## Engineering Services Committee ATTACHMENTS

ITEM	PAGE
<b>8.2 Moutere Highway/Waimea West Road/Golden Hills Road Safety Improvements</b>	
1. Appendix 1 - Police Traffic Investigation Report.....	5
2. Appendix 2 - Coroner's Report.....	79

**SAFETY AUDIT RESPONSE FORM**

*(By way of an example, a diagram is attached on the following page.)*

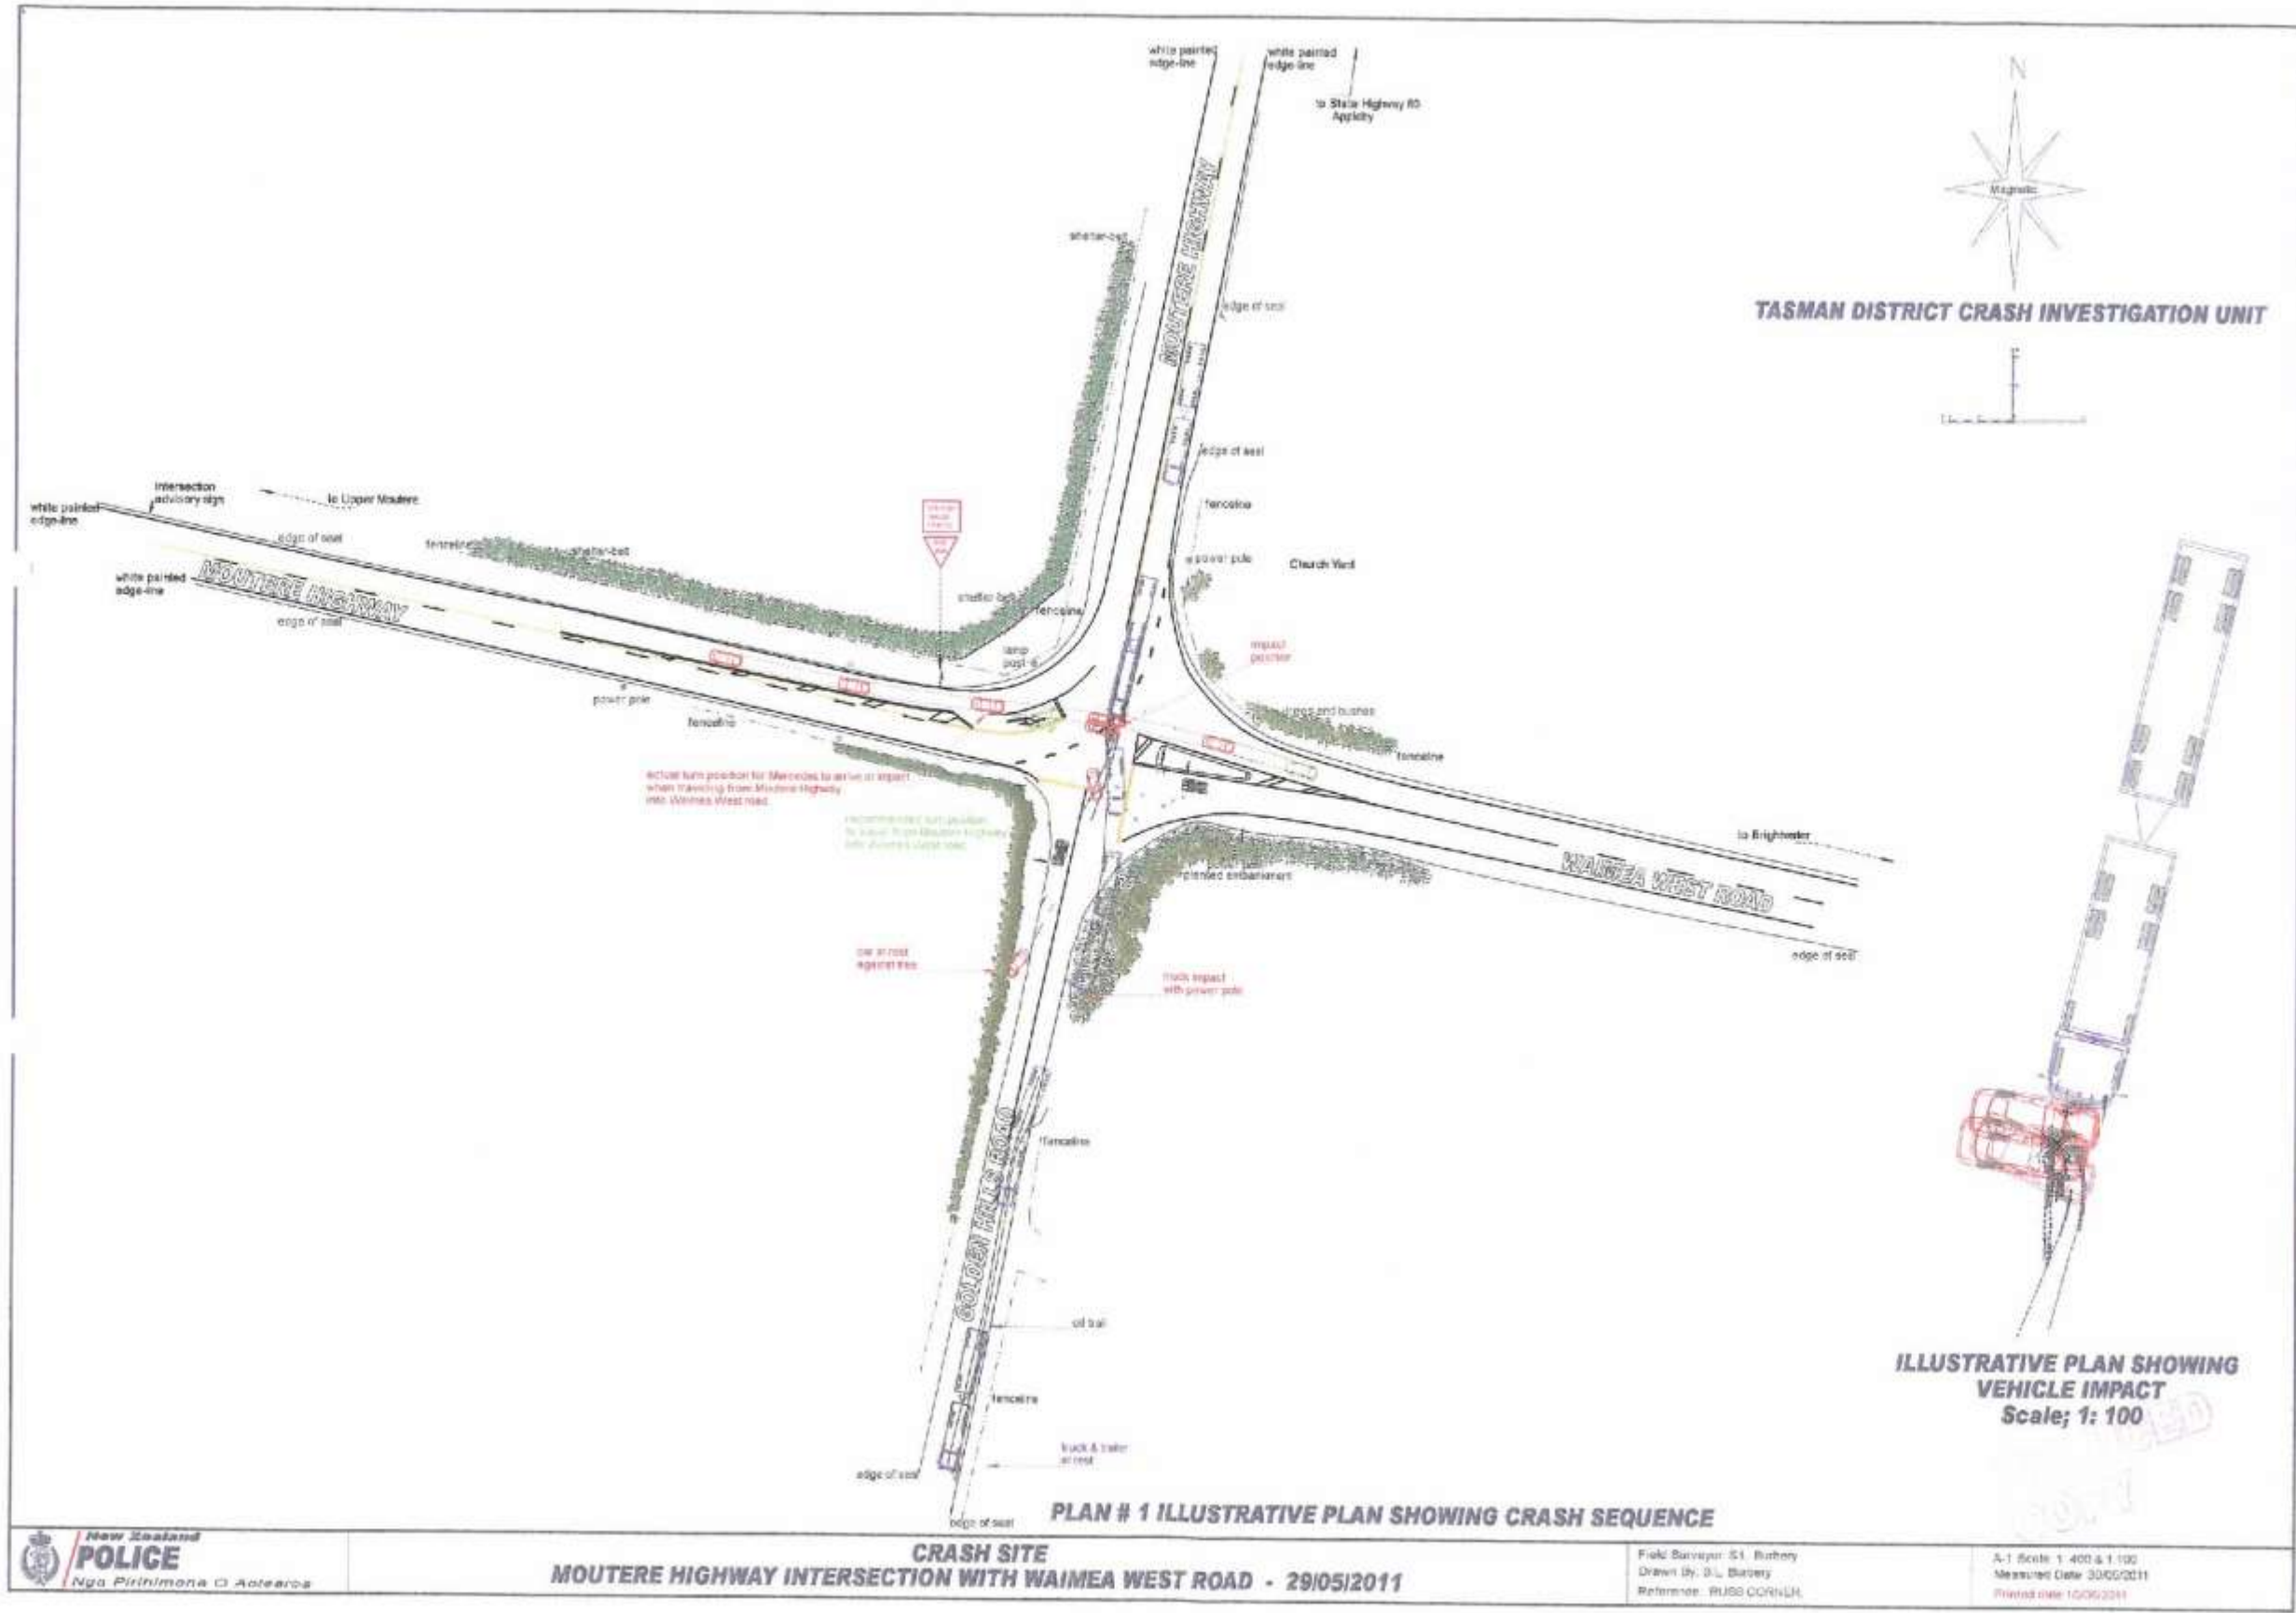
It is suggested that a copy of this report be forwarded to the Road Controlling Authority requesting that they re-examine the layout of this intersection with a view to consider installing some form of raised concrete edging to run around the outside of the turn lane to ensure compliance with it.

By providing a physical guide to traffic it would ensure traffic would have to slow to a maximum of 35-km/h and bring them to a place where unobstructed vision between themselves and southbound traffic exists.

Additionally it would be helpful to find some way of physically encouraging southbound traffic travelling into Golden Hills Road to slow to a more defensive speed when travelling through the intersection, or at the very least install an advisory sign warning of the possibility of crossing traffic.

- hand drawn concept plan dated 6 September 2012 (1:250 scale at A3);
- tech memo 1;
- tech memo 2;
- tech memo 3.

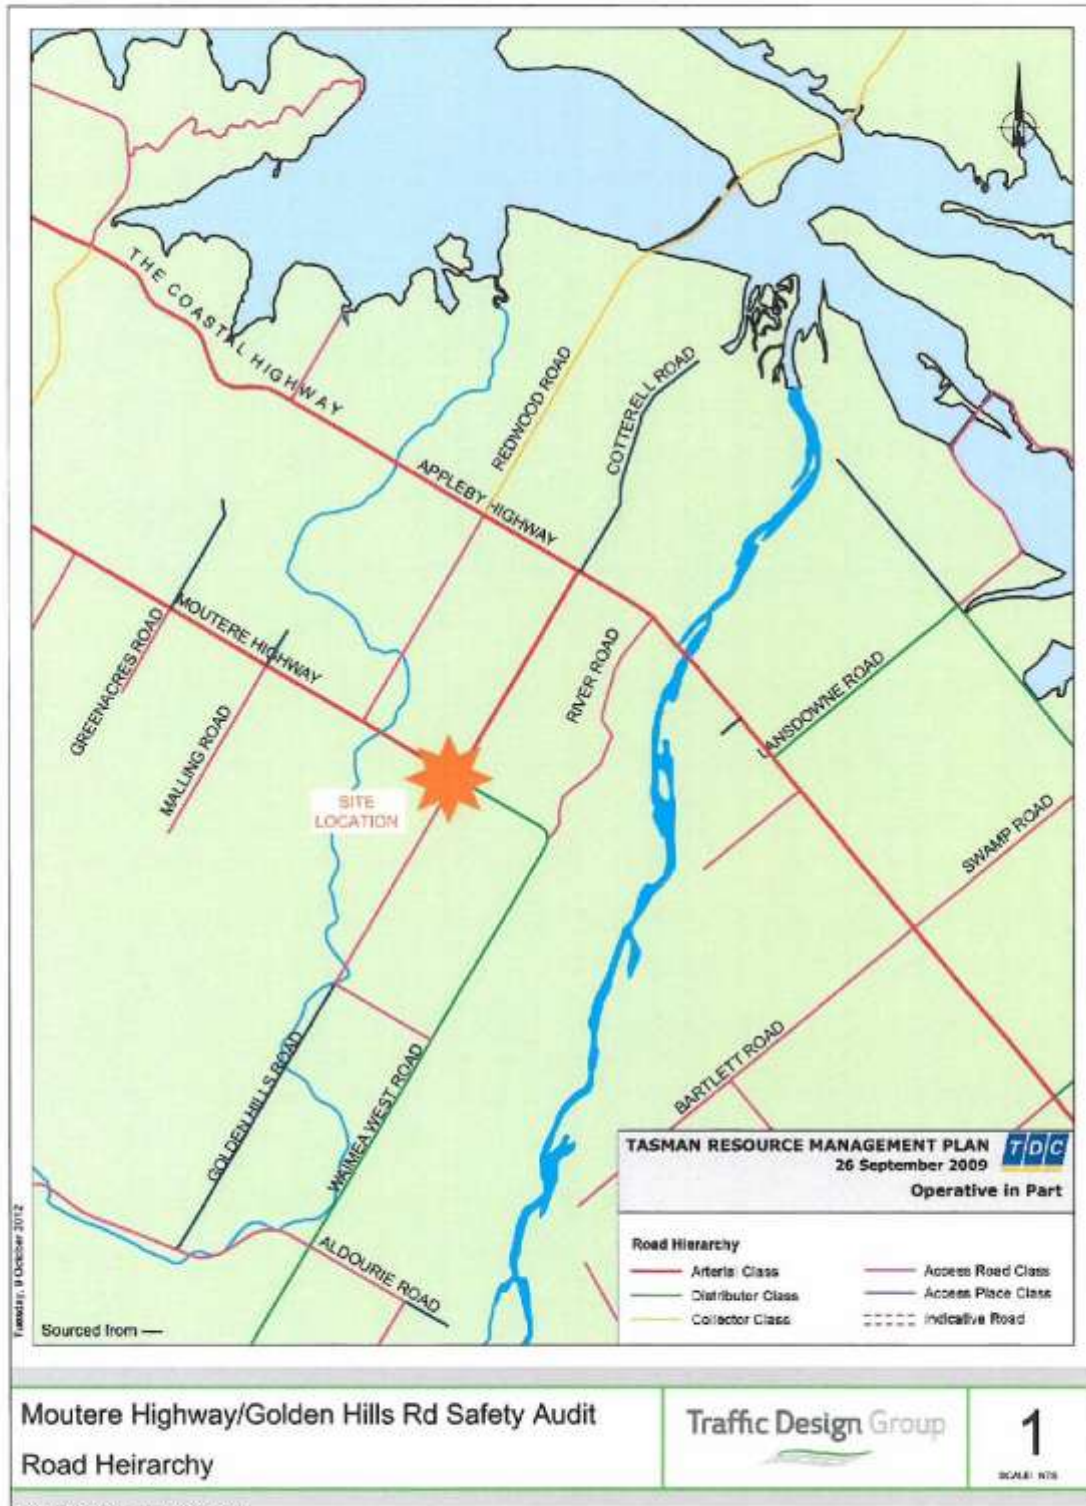
It is understood that the central island will include a skirt although such provision is not shown on the concept plan. Even with the potential easing of the path for right-turning trucks in particular that will result, it is considered that some increase in the inscribed diameter may be warranted, in view of the very high proportion of large right turning vehicles at this location. Acknowledging that the majority of drivers are expected to be local, and who have habitually driven this intersection in its current format, there may be a tendency for drivers to attempt to circulate around the roundabout at too great a speed. In this respect, it is noted that experience elsewhere has shown that this can lead to truck roll-over. For this reason, it may be prudent for Council to consult local transport operators with a view to education on the need for taking due care in negotiating the roundabout prior to its implementation.

From the briefing, it was understood that sightlines were measured from 9m back from the stop-line, with the setting back of property boundaries shown so as to provide clear lines of sight of some 60m on three of the four approaches to the roundabout. Scaling of the concept plan suggests that the sightlines may only be available from a point some 7-8m back from the limit lines on three of the approaches. It is acknowledged that property constraints restrict the approach sightline to some 45-50m from the fourth (Golden Hills) approach, from a point 9m back from the limit line, even if the batter is completely cleared of existing vegetation, shown in Photo 2.

Although not clearly identified by the concept plan, it is assumed that all approaches are kerbed. The SAT note that the approach lane widths scale at between 3.5 and 4m between kerbs. This is below the minimum width for an approaching vehicle to be able to pass a disabled vehicle (or a cyclist) on the approaches. It is considered that the approaches need to be widened accordingly. Options that could be considered include widening from the start of the splitter island to at least as far as the entry to the alternative cycle path (and this will likely assist with the design of the ramp transition for the cycle path). Alternatively, the cycle path might be extended back to the start of the splitter island.

The SAT acknowledges that the width of the cut-downs as shown in the concept plan is a function of the geometry of a small radius roundabout such as this. It is considered to be adequate for pedestrians but not sufficient to fully 'protect' a cyclist crossing the road. The SAT note the low volume of inexperienced cyclists and the likelihood that more experienced cyclists may stay on the carriageway.

The SAT acknowledges the need for relocation of some poles as noted on the plan, and of the desire of the service company to maintain the existing pole alignment. As a consequence, it is observed that some poles will remain close to the carriageway. Although recognising that this is generally an improvement on the existing situation, they will all be relatively close to the intersection.

It is noted that as currently shown on the concept plan, the splitter island will block vehicle access to/from the church driveway on the Moutere north approach, some 40m from the intersection, as shown in Photo 3.
